W_CN4

2010.11.30

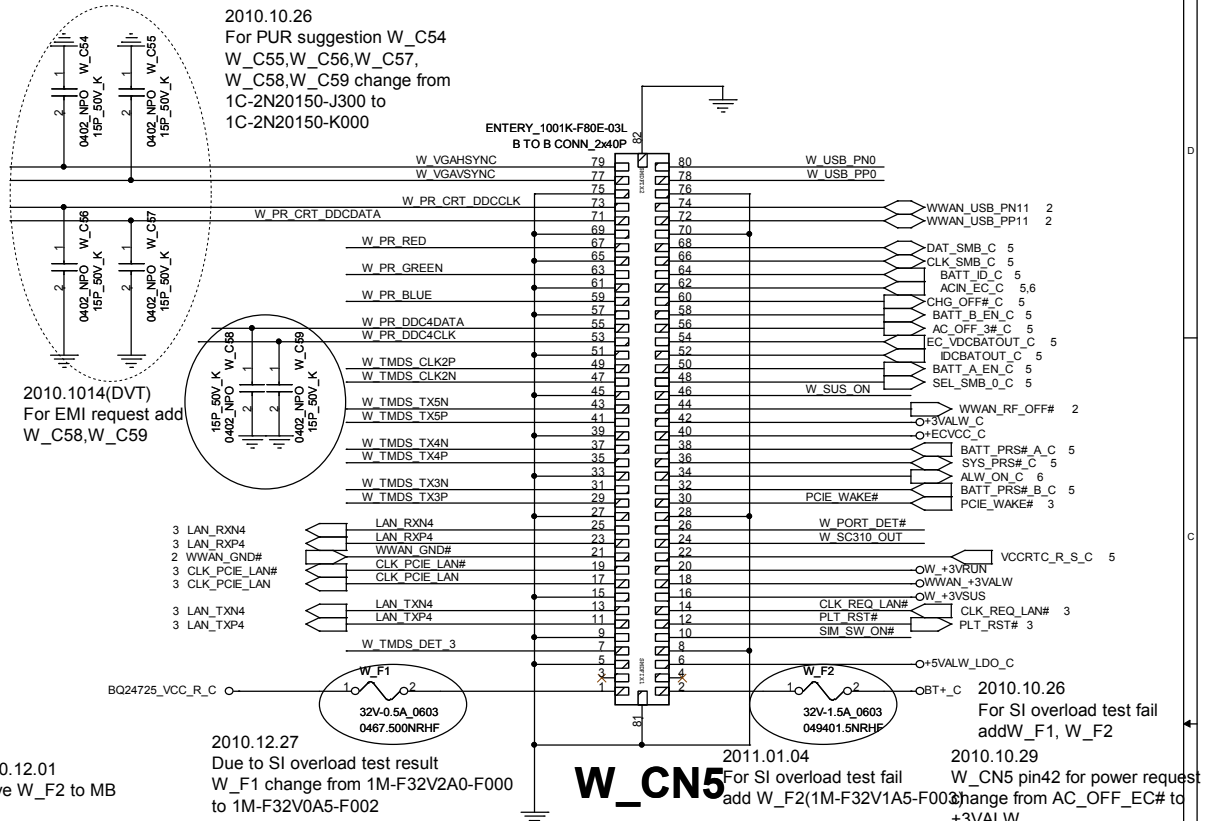
For EMI request W_C53 change from NC to mount, add W_C60

2010.1014(DVT)
For EMI request add W_C58, W_C59

2010.10.26
For PUR suggestion W_C54
W_C55, W_C56, W_C57,
W_C58, W_C59 change from
1C-2N20150-J300 to
1C-2N20150-K000

2010.12.27
Due to SI overload test result
W_F1 change from 1M-F32V2A0-F000
to 1M-F32V0A5-F002

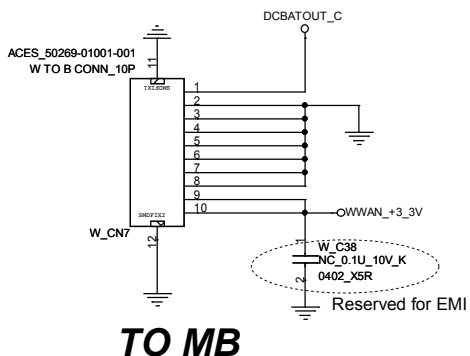
2010.12.01
Move W_F2 to MB

2011.01.04
For SI overload test fail
add W_F2 (1M-F32V1A5-F003)
change from AC_OFF_EC# to
+3VALW

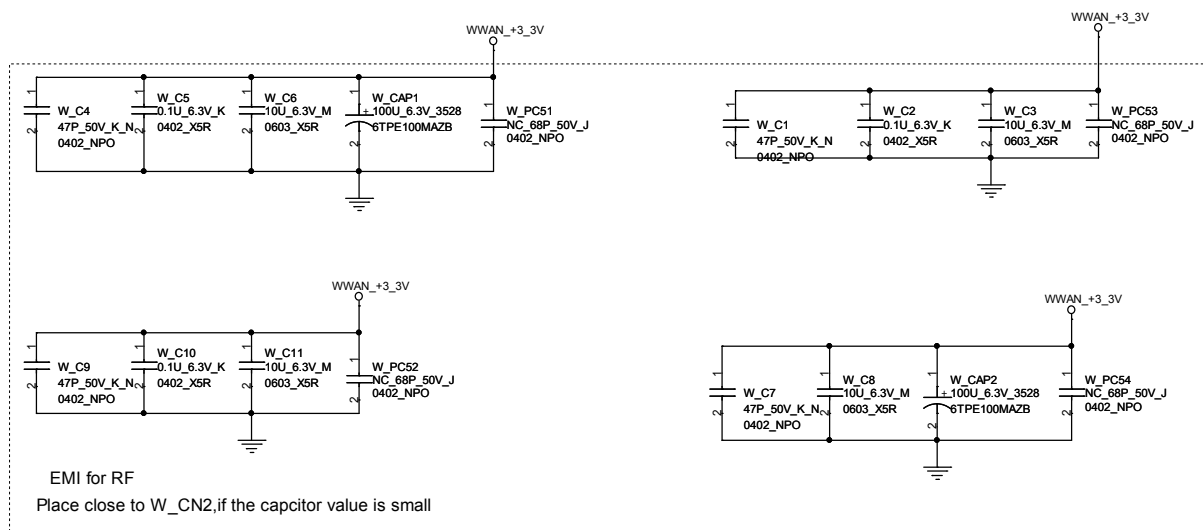
Add follow MOR request IRX-5580_Wireless-Schematics-Guideline_r050_100701_dist.pptx

add one 0.1uF capacitor

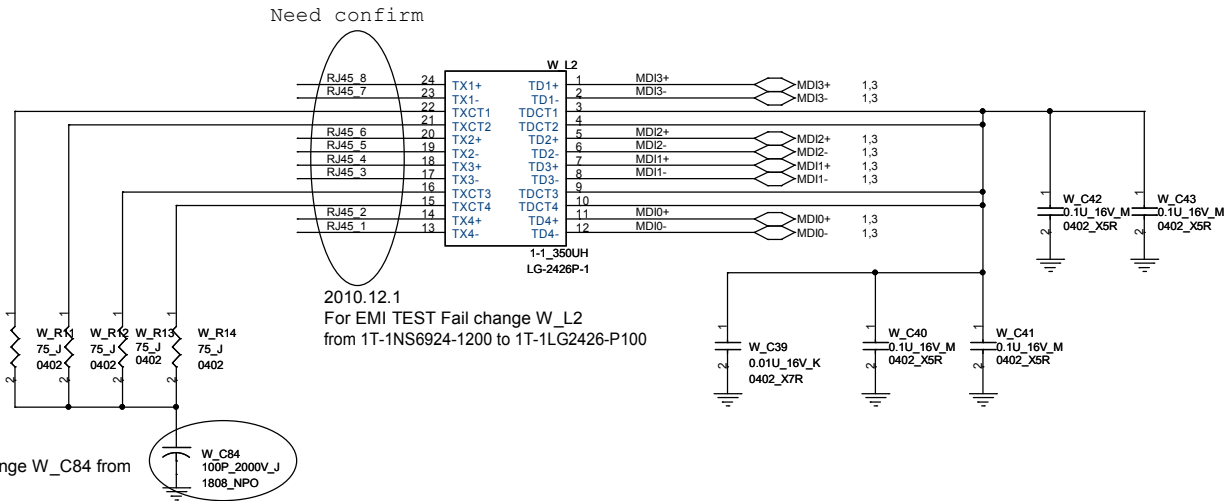
Using eFUSE without ASF
For RTL8111E mounted R16&R17

2010.10.16 /
For crystal clock issue
W_C44,W_C45 change
from 27pF to 22pF

2010.11.21
For SI crystal test fail
W_C44,W_C45 change
from 22pF(1C-2N20220-J000)
to 12pF(1C-2N20120-K000)

2010.12.24
Adapter ISN EMI test fail change W_C84 from
1500pF to 100pF

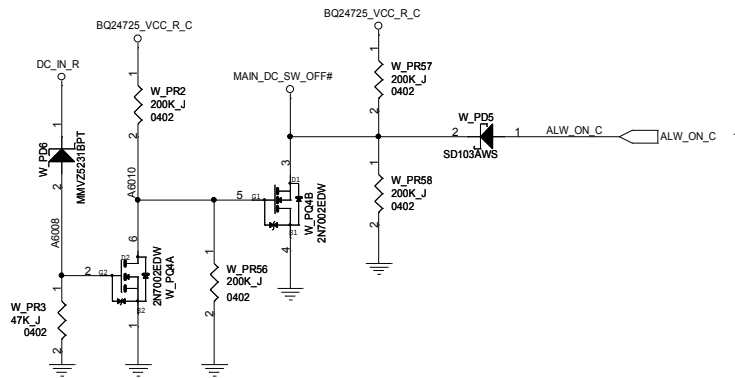
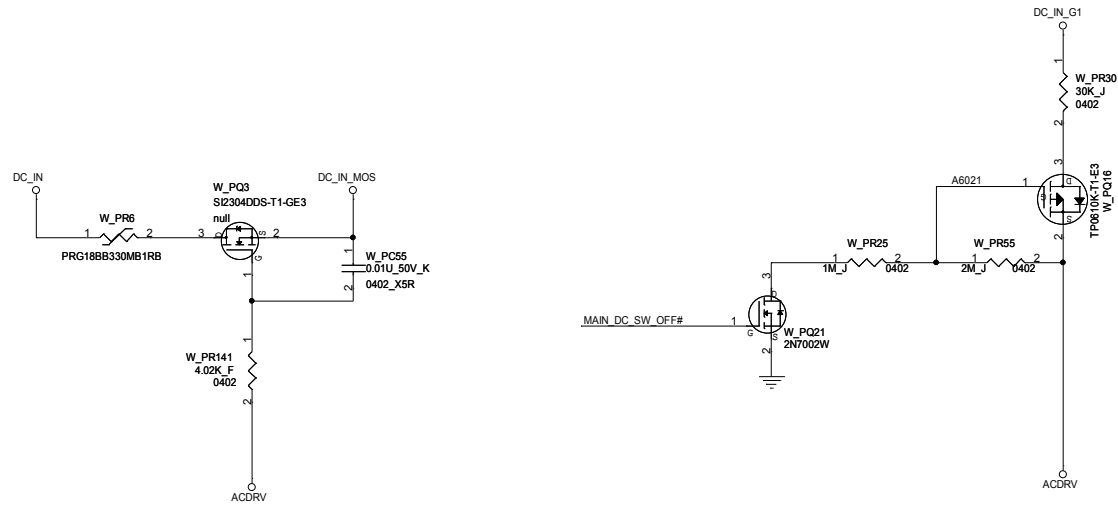
2010.12.27
For PVT charger LED Blinking issue
W_PR9 pull high to +3VALW
W_R23 change to 300K(1R-000304-F200)

For power request delete W_PQ17
W_PR9 change from 300K
to 47K, W_PR28 from 62K to 47K

2010.11.25(PVT)
For cost reason Delete zero standby circuit W_PR45,W_PR50,W_PR53,W_PR43,W_PR44,W_PR52
W_PR62,W_PR41,W_PR63,W_PR61,W_PC39,W_PU5,W_PU3,W_PQ19,W_PQ18
